From: Kolosseus, Andrew (ECY) [mailto:AKOL461@ECY.WA.GOV]
Sent: Tuesday, December 06, 2016 8:11 AM
To: Zell, Christopher <zell.christopher@epa.gov>; Weiss, Leanne (ECY) <lewe461@ECY.WA.GOV>
Subject: Budd Inlet

I made a couple of notes from last week's EPA-Ecology meeting on Budd Inlet / South Puget Sound. I wanted to make sure I heard correctly and that we remember where we ended up. Can you both take a look at this and let me know if this is correct?

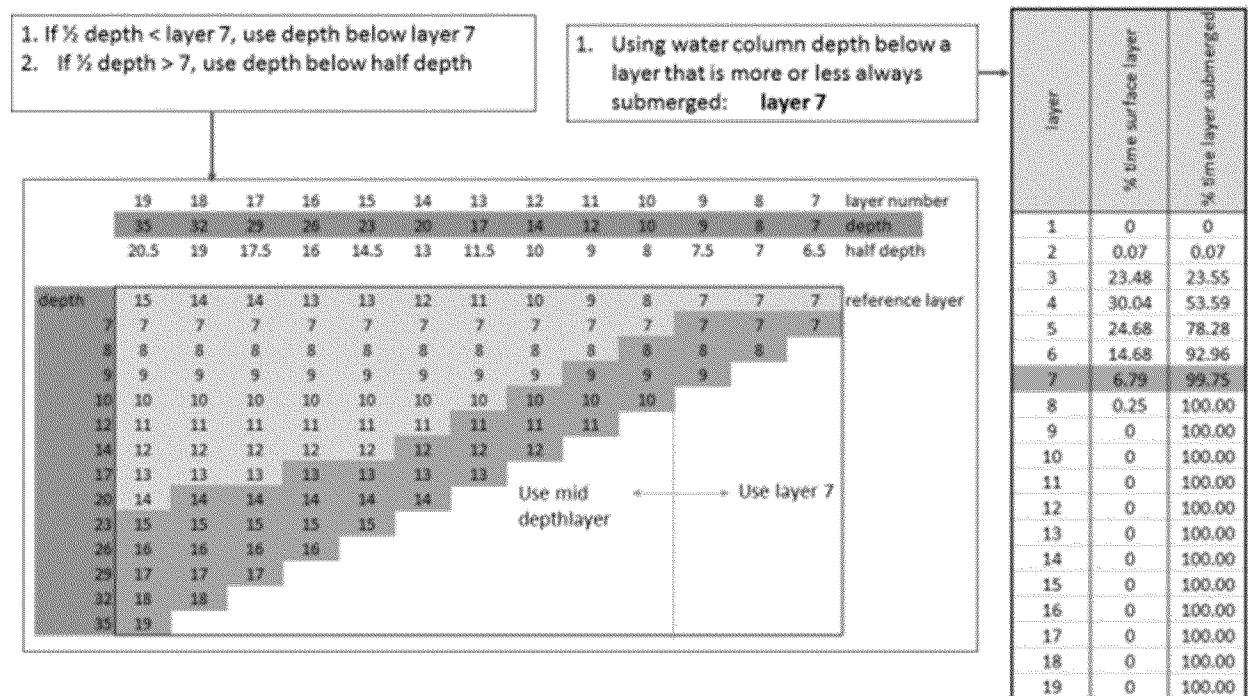
And there was a brief mention of vertical averaging on the Puget Sound DO project. We're already doing this in Budd Inlet. Chris, please take a look at our approach – attached as a slide, below (let me know if it doesn't come through). Let us know asap if you have an issues with this approach. The basic idea is that model layer 7 has water in is 99.75% of the time (i.e. layer 7 is subtidal). Therefore, in areas of the model with 7, 8, or 9 layers we average layers 7 through 9.

In deeper waters, we used the mid depth layers. It's the layers in the darker gray in the plot that we averaged. This approach was used for the slides from the November advisory committee meeting update that I sent to you earlier. If you have concerns or questions, we should add this to the future conversations in #3.
